DETAILED ACTION

Art Unit: 2851

FIG. 3**Drawing 1** Location of first cross-section shown.

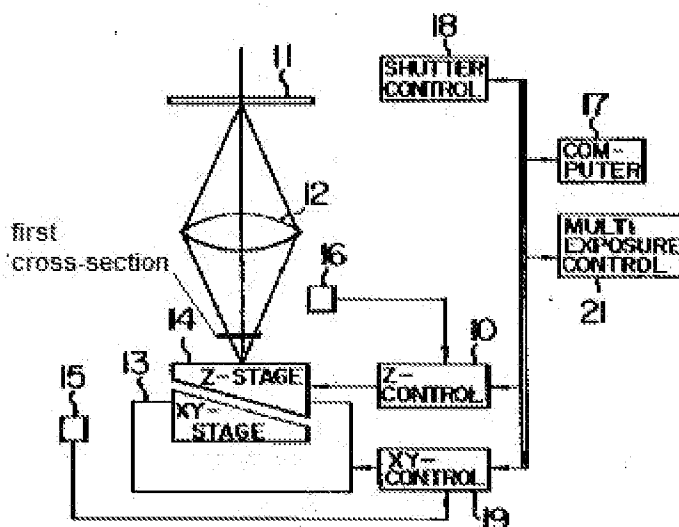
Re claims 5 and 1: Fukuda discloses a system [Fig 3] for recording a pattern 11, comprising:
a controller 17, for determining an illumination scheme [via multi-image using exposure control system 21] in response to the pattern; and

optics [shutter controlled by shutter control system 18], coupled to the controller, for directing, in response to the determination, at least one beam of radiation [C11L62-63: excimer laser] having a first cross-section [see line in Drawing 1] towards a reversible transmission film 44 so as to allow a portion of said beam to propagate towards a radiation sensitive layer 42, wherein the portion has a second cross-section [see grooves between resist pattern 46 in Fig 8d] that is smaller than the first cross-section.

Re claims 7 and 3: Fukuda discloses wherein the second cross-section [see Fig 8d] is about half of the first cross-section [see Drawing 1].
